11th May 2007
Ref: 1377

Mr Roger Bennion,
Planning Department,
Flintshire County Council,
County Hall
MOLD
CH7 6NF

**PARRY'S QUARRY ENVIRONMENTAL STATEMENT ADDENDA AND
RESPONSES TO CONSULTATIONS**

PARRYS QUARRY PROPOSED LANDFILL SITE

Figure 1: Sur

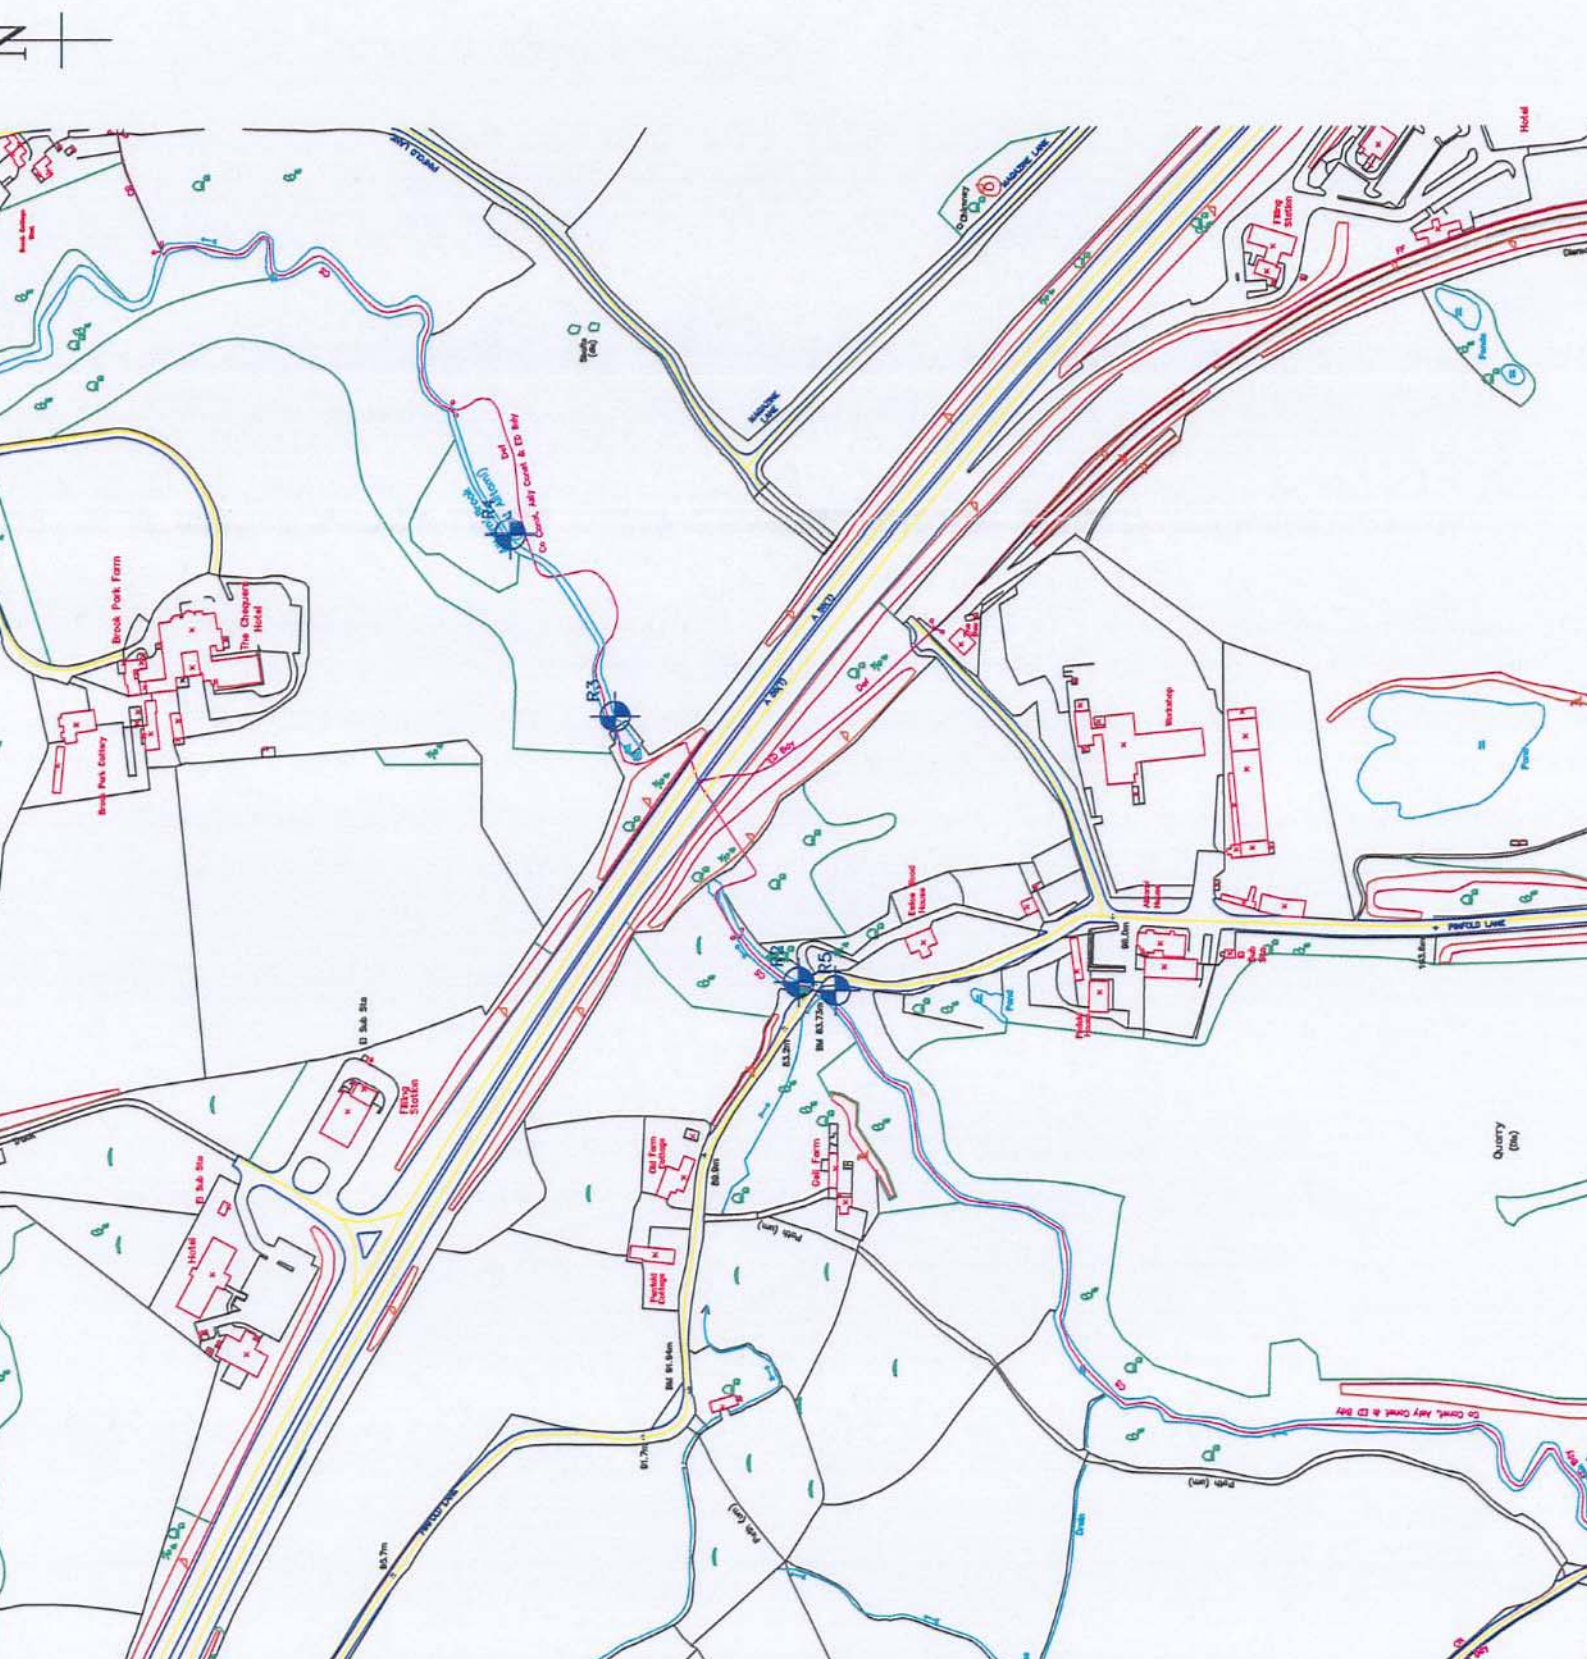
The locations are shown on Figure 1. Location R5 is at the discharge pipe from Parry's Quarry immediately prior to the discharge point into the Alltami. R2 is on the Alltami immediately downstream of the discharge point. R6 is on the Wepre immediately downstream of the Wepre / Alltami confluence, R6a is on the Alltami immediately above the confluence and R6b is the difference, ie the flow of the Wepre. These measurements were taken during a relatively dry period and are likely to approximate the seasonal base flow rate. The 29 March measurements were after around three weeks during which there had been no significant rainfall. The data suggest that the Alltami is receiving water from groundwater between R2 and R3 and losing water to groundwater between R3 and R4 and between R4 and R6a. This conclusion can only be considered tentative at this stage because of the methodology (impeller flow meter in a rather irregular stream bed configuration) and the measurement frequency (two spot measurements). If this conclusion is accurate, then groundwater flow via the fault / fracture systems is suggested and flow into the Gwespys Sandstone from the Alltami stream in the fault block in which R4 is located may be occurring.

Figure 2

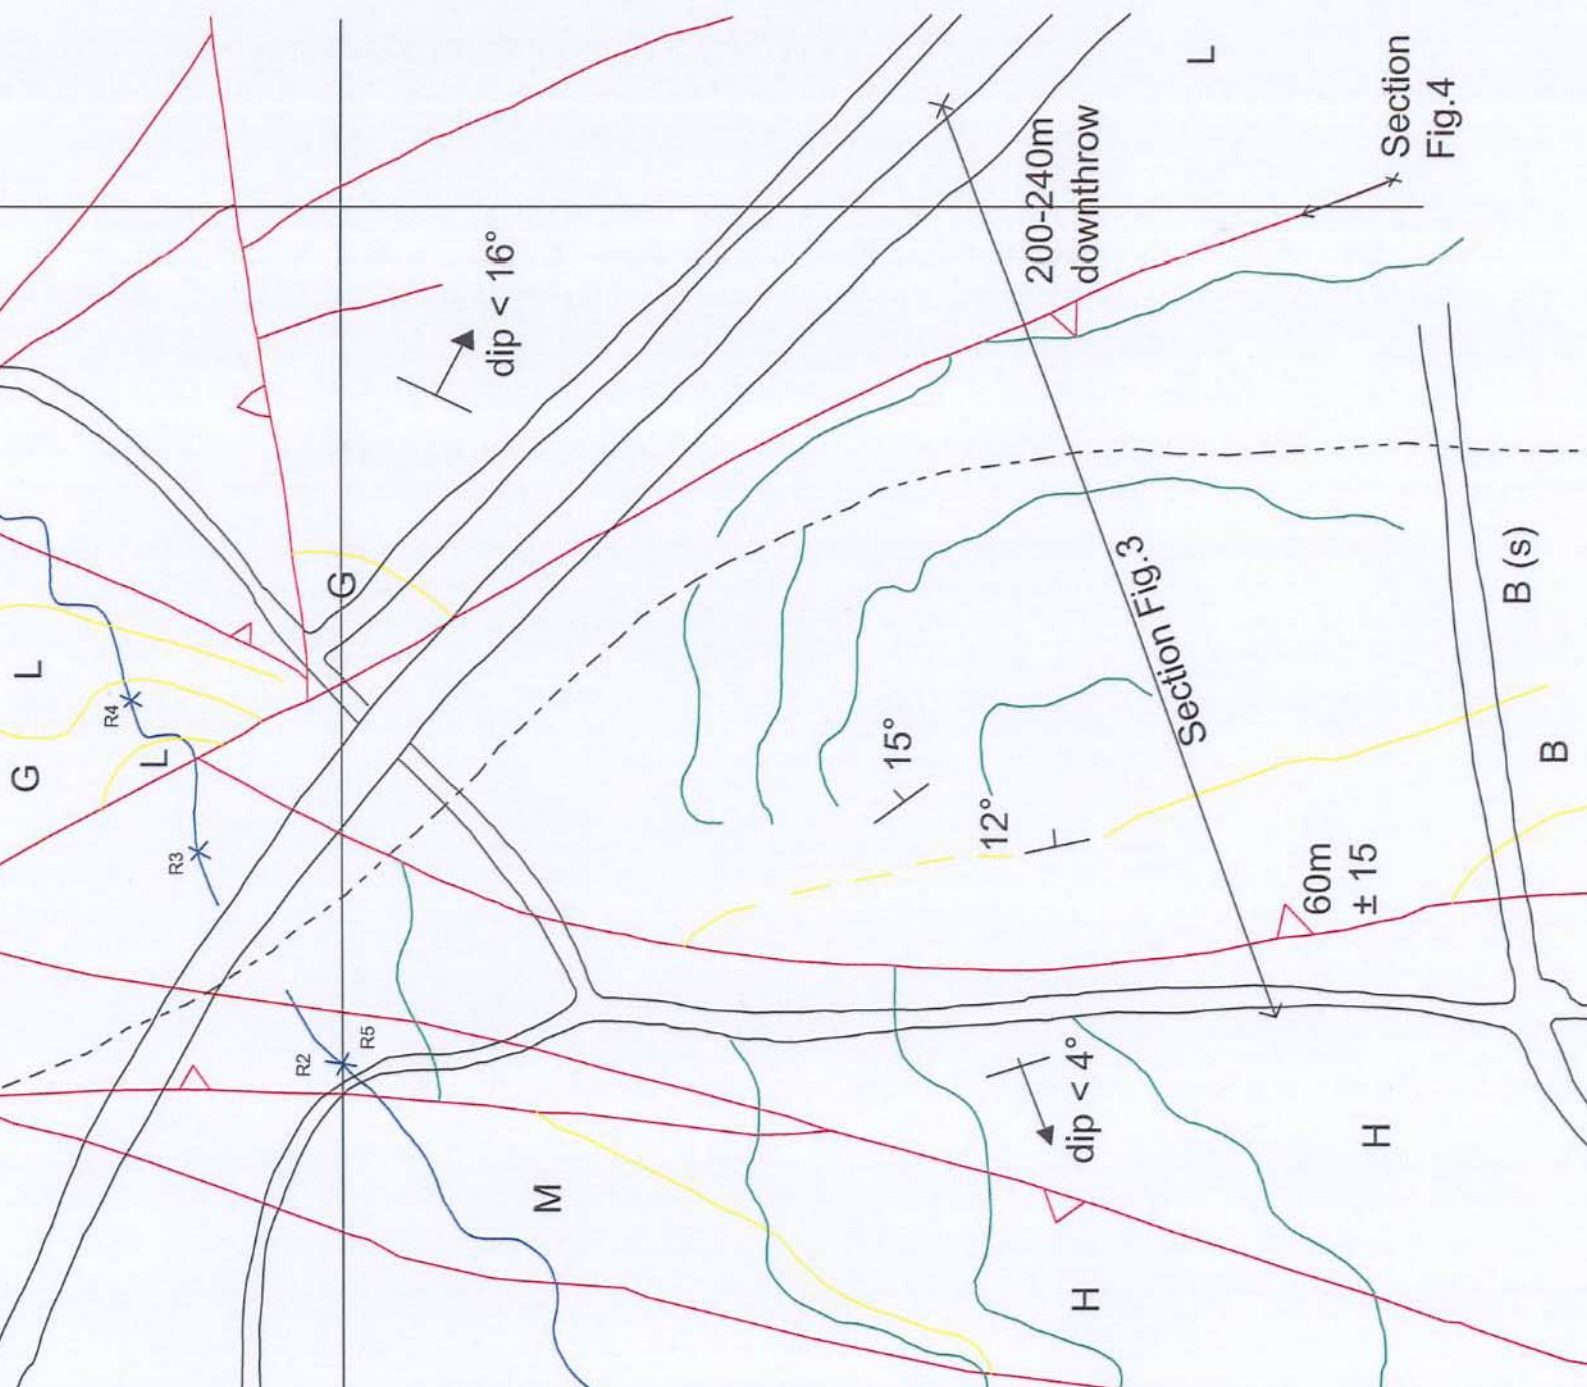
Based on the 1:10,000 geological map of the area the downthrows of the faults immediately to the east and west of the site have been estimated at 200 – 240m for the former and 60m +/- 15m for the latter, see Figure 2.

Figure 2 (geological map) indicates that the dip of the block immediately to the east of site and down hydraulic gradient from it is towards the south east at around 16 degrees whilst that of the block at the site is to the north east (see Figure 4). Also the proportion of the potentially more permeable strata such as sandstones or even silty sandstones is limited. The combination of these two factors indicates that the opportunity for permeable strata to abut other permeable strata across a fault, assuming the fault permitted flow, is very limited. It is therefore much more likely that flow will be controlled by fractures rather than primary permeability.

Figure 3: Ge
(Parallel to Direc

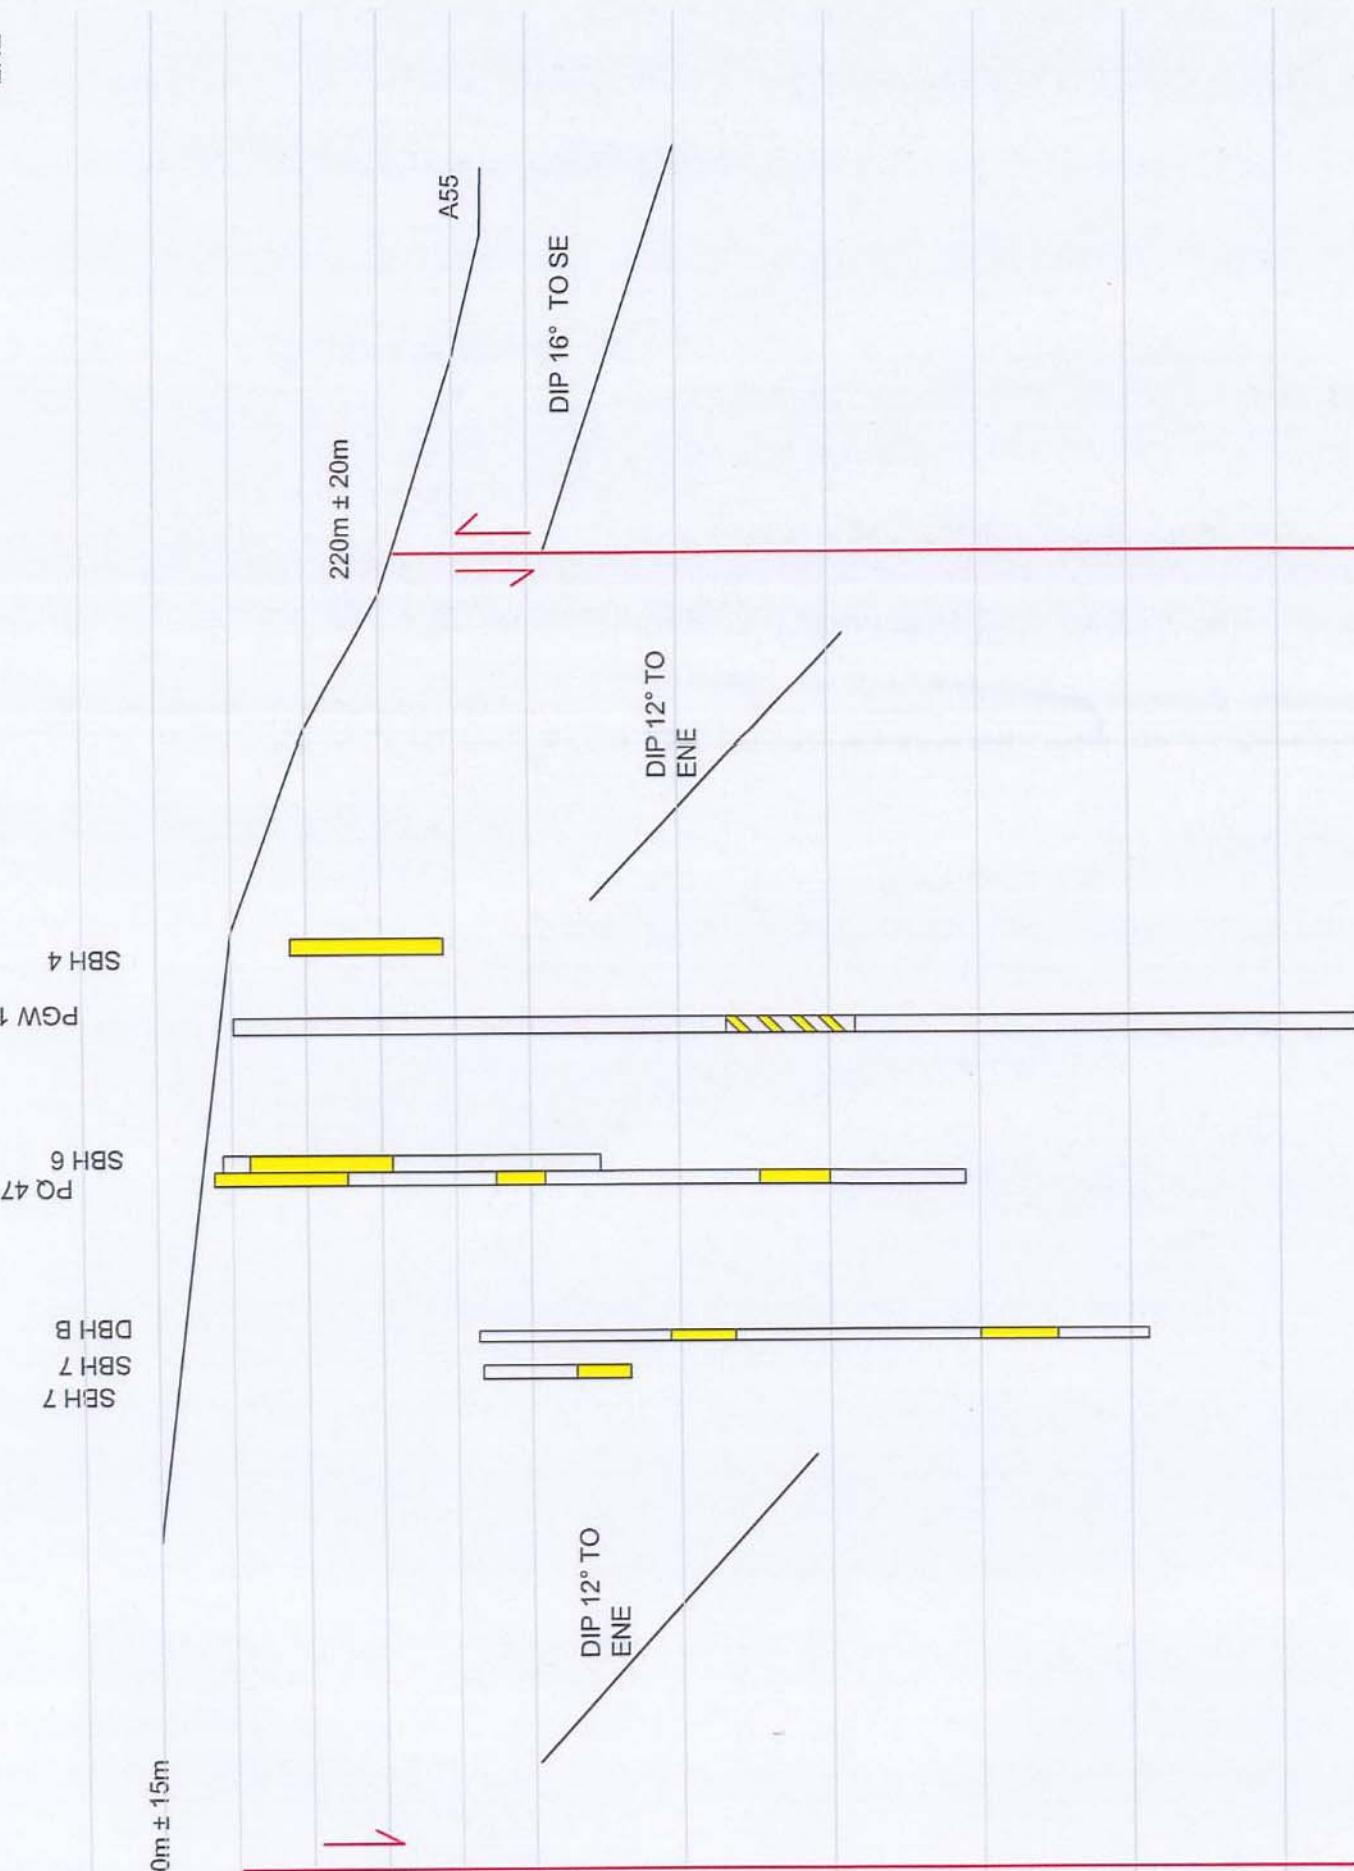
Geological Sections are presented in Figures 3 and 4. Figure 3 is parallel to the direction of dip observed in the fault block in which the site is located and includes data from boreholes SBH4, 6 and 7, DBHB, PQ4 and PGW1. The section shows that it is difficult to identify clear marker horizons. However, the sandstone layer immediately beneath the drift deposits in the area of the site is apparent though the dip cannot be confirmed due to PGW1 not identifying it and SBH4 not penetrating it.

Figure 4: Secti
Eastern Edge of

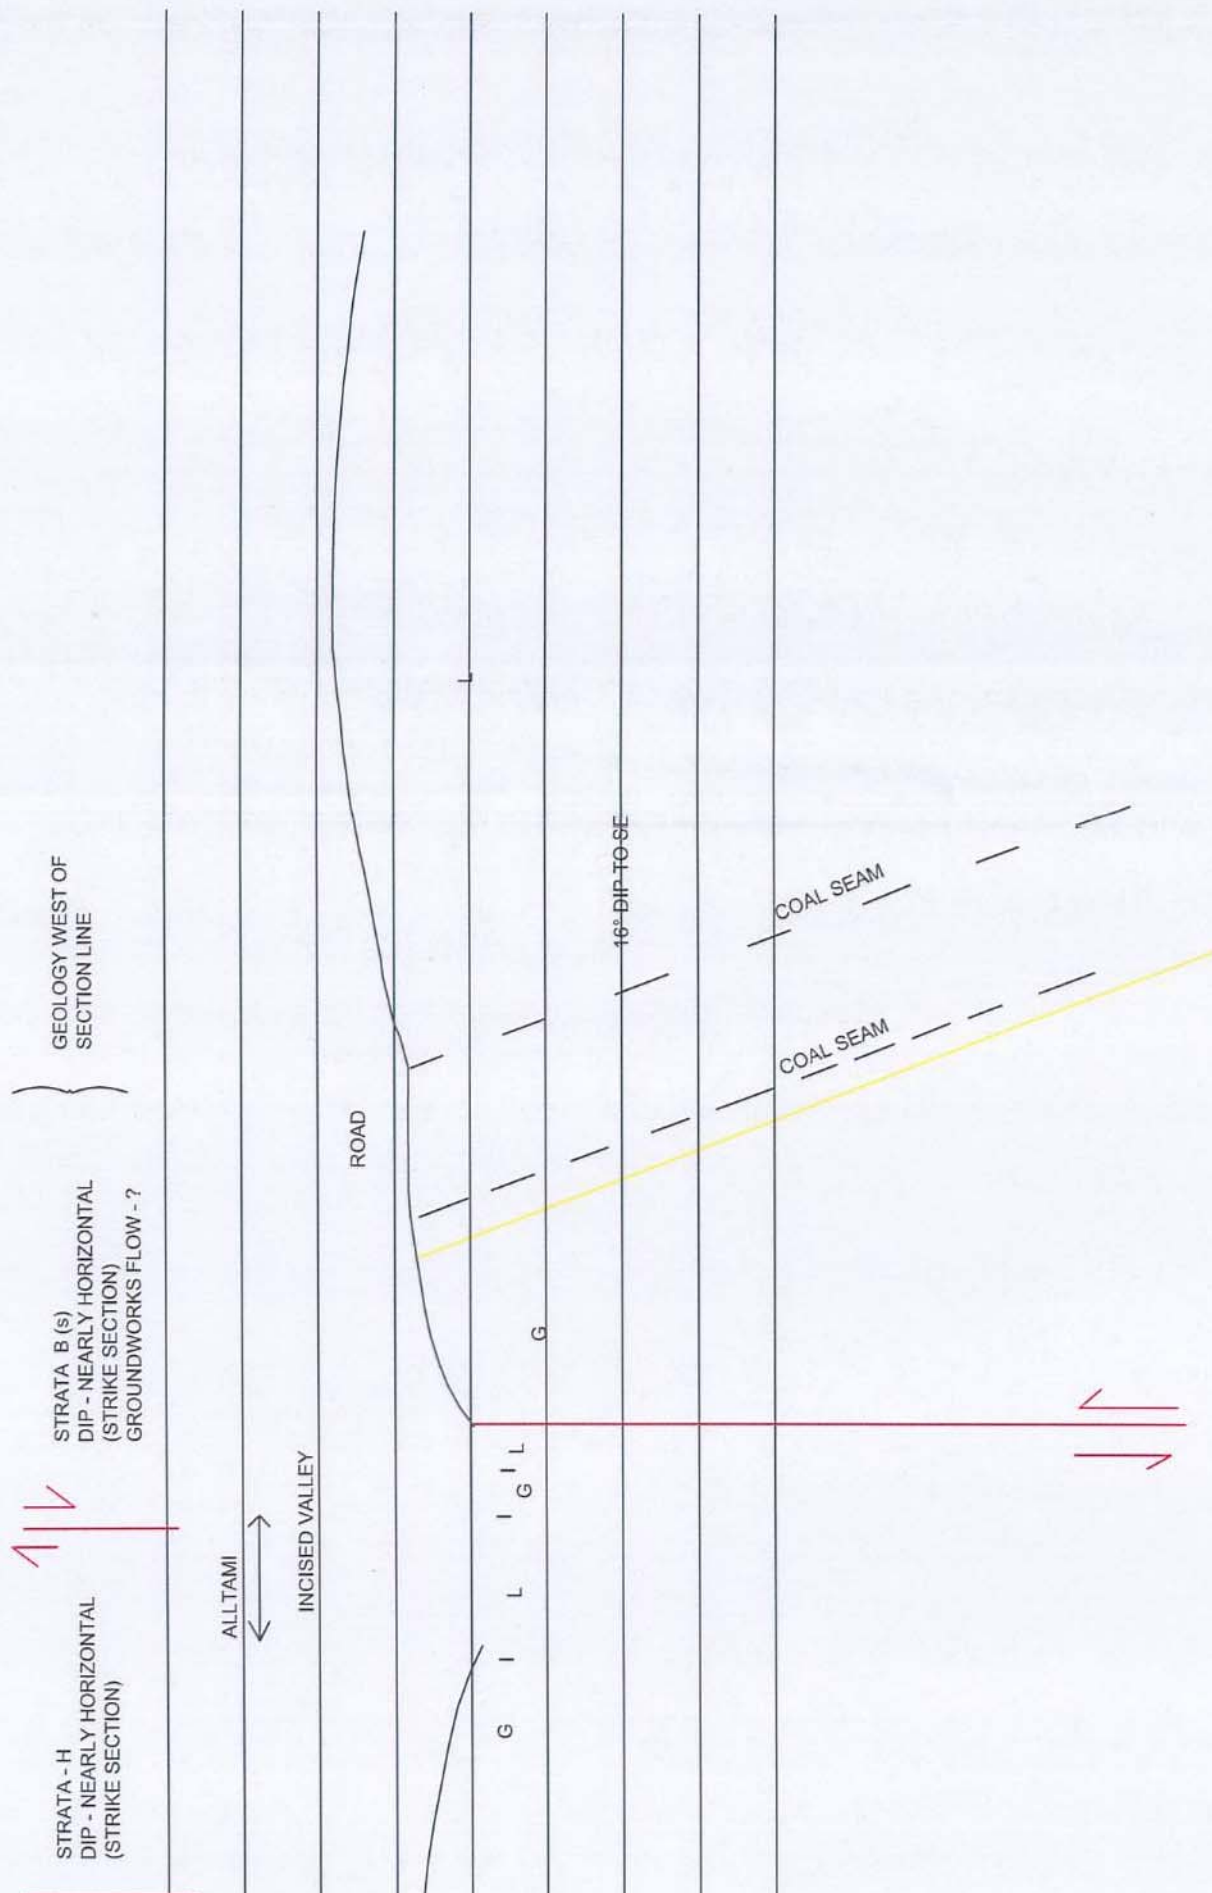
Figure 4 is a strike section along eastern site boundary fault and presents data regarding the strata looking eastwards and superimposes the strata encountered west of the fault line.
